Peoria Park District  
Bradley Park Equipment Service Center  
1314 N. Park Road  
Peoria, IL 61604  
Telephone: (309) 686-3386

ADDENDUM NO. ONE

PROJECT TITLE: Charter Oak South Dam Repair

ISSUANCE DATE: June 19, 2013

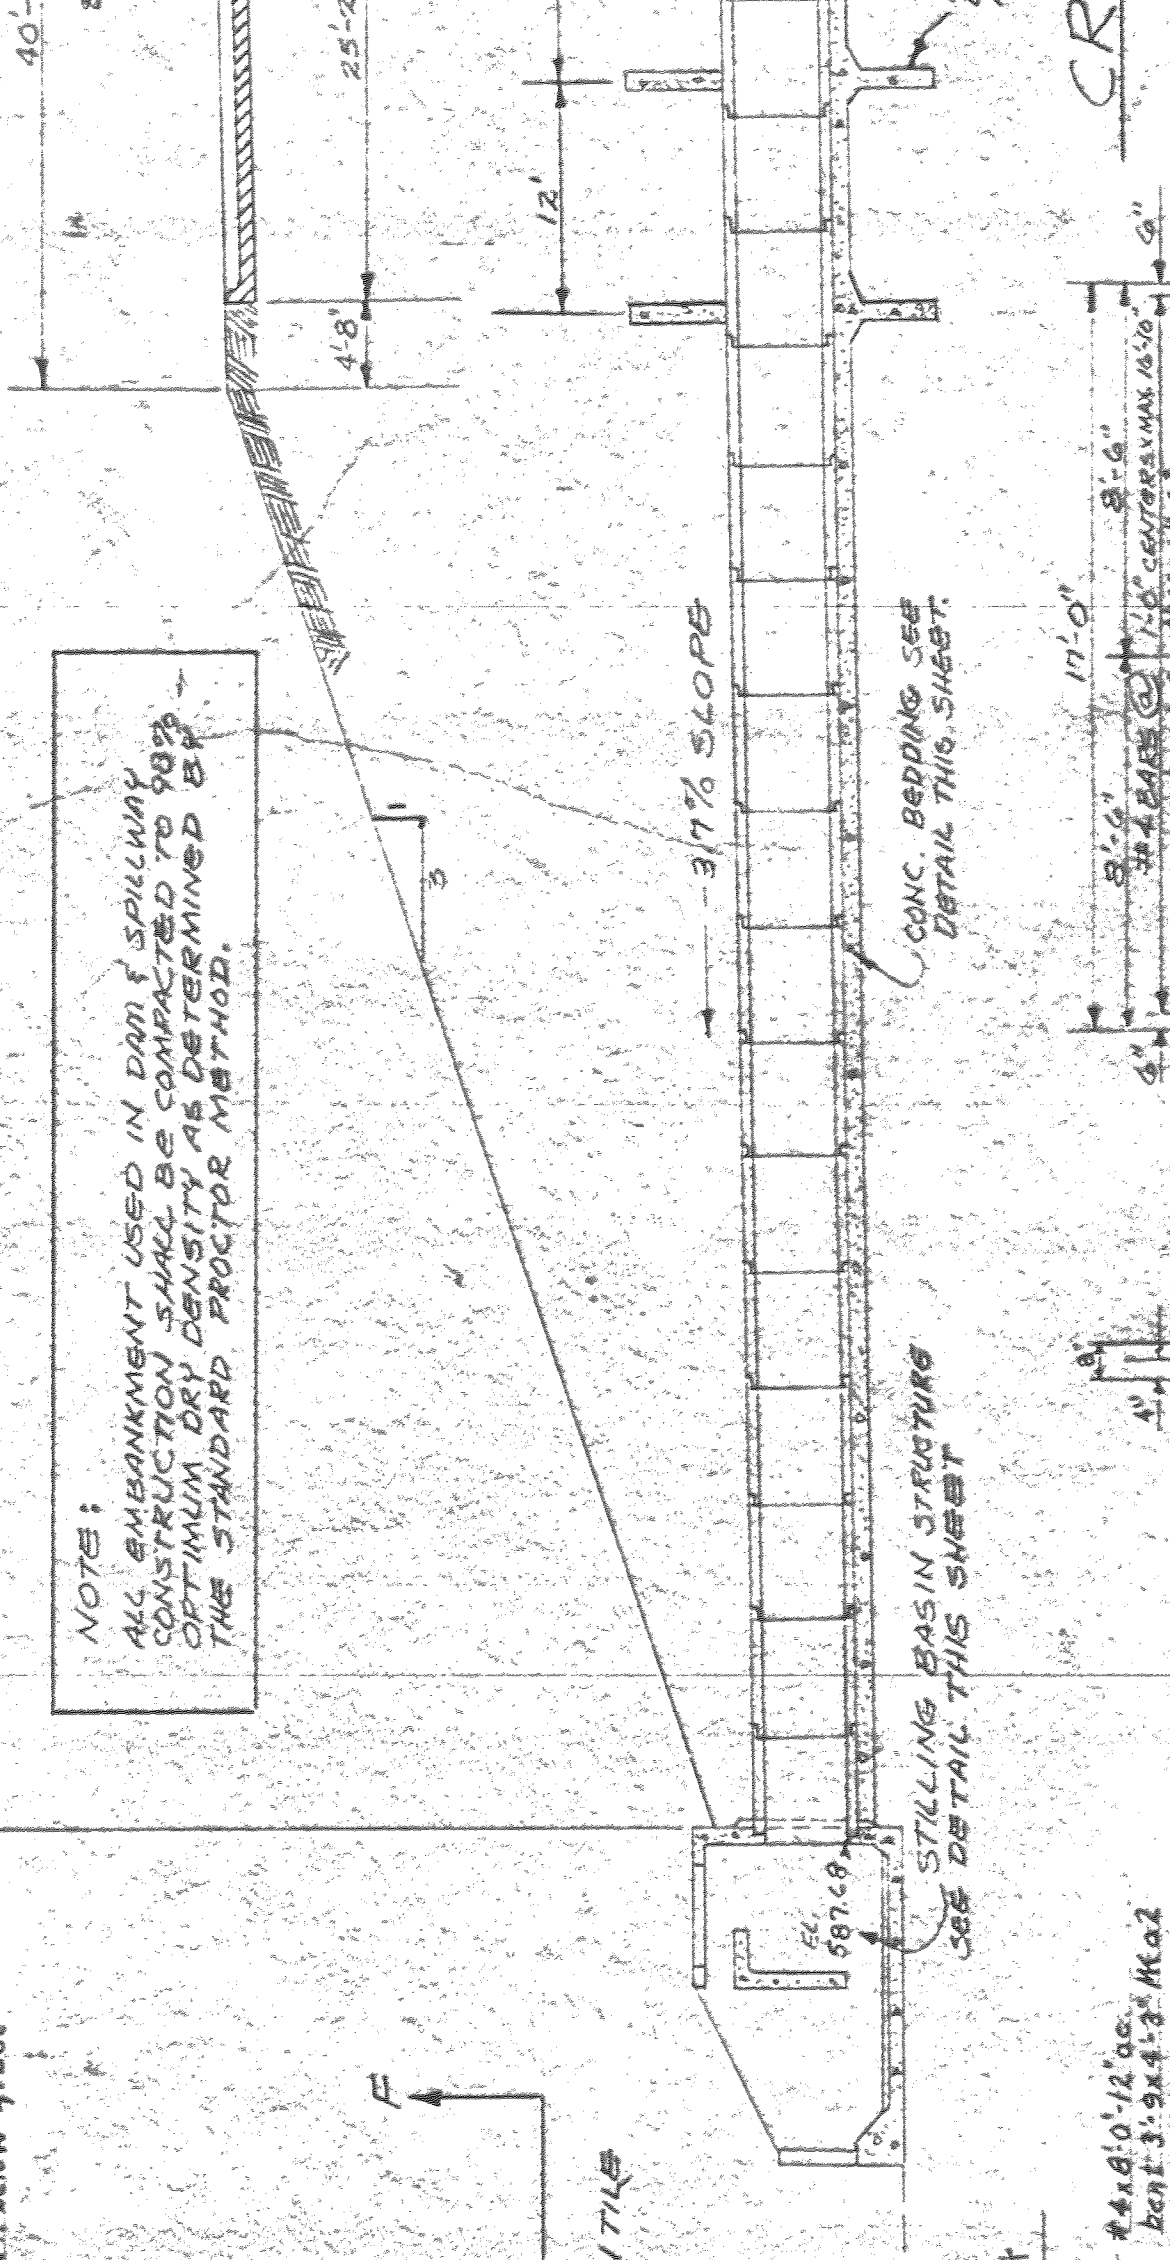
For clarification, a sheet showing the original plans, and a sheet of images of before and after the 2010 repair is attached.
